Access Compliance Report

Public Rights-of-Way

(Curb Ramps)

Intersection ID: 13292	Main Street: E_3RD_ST	Cross Street: S_MCDOWELL_ST	Location: E
ADA ID: 09389A2EE550	Ramp Type: PerpDiag	Initial Pass/Fail: Fail	Overall Compliance: No
Severity Score: 10			
Codes/Mitigation Info/Possible Solution		Field Measurements/Component Compliance

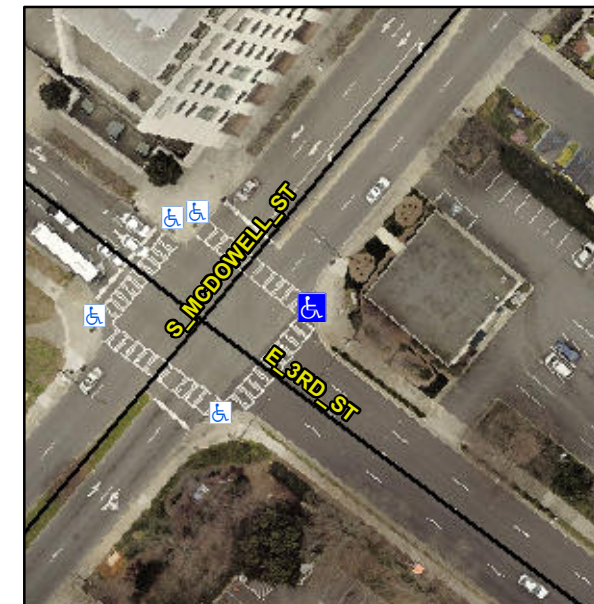
Not Found, R304.5.1

Compliance	Description	Data	Compliance	Description	Data
N/A	Ramp Length (in)	104.0	Yes	Ramp Slope (%)	5.2
No	Ramp Width (in)	38.0	Yes	Ramp XSlope (%)	2.4
N/A	Flare Type LT	N/A	N/A	Flare Type RT	N/A
N/A	Flare Slope LT (%)	N/A	N/A	Flare Slope RT (%)	N/A
N/A	Flare Traversable LT?	N/A	N/A	Flare Traversable RT?	N/A
N/A	Landing Length (in)	N/A	N/A	DWS Provided?	N/A
N/A	Landing Width (in)	N/A	N/A	DWS Contrast?	N/A
N/A	Landing Slope (%)	N/A	N/A	DWS Length (in)	N/A
N/A	Landing X Slope (%)	N/A	N/A	DWS Full Width?	N/A
N/A	Landing Curb? (Y/N)	N/A	N/A	DWS Offset (in)	N/A
N/A	Shared Landing?	N/A			
N/A	Gutter Ponding?	N/A	N/A	Gutter Slope (%)	N/A
N/A	Gutter Lip Ht (in)	N/A	N/A	Gutter X Slope (%)	N/A
N/A	Painted X Walk1?	Yes	N/A	Painted X Walk2?	Yes
	X Walk 1 Direction	To NW		X Walk 2 Direction	To SW
N/A	X Walk 1 Width (in)	118.0	N/A	X Walk 2 Width (in)	112.0
	X Walk 1 Slope (%)	4.1		X Walk 2 Slope (%)	0.1
	X Walk 1 X Slope (%)	0.2		X Walk 2 X Slope (%)	2.9

Remove & Replace Curb Ramp With Two New Directional Ramps or Equivalent.
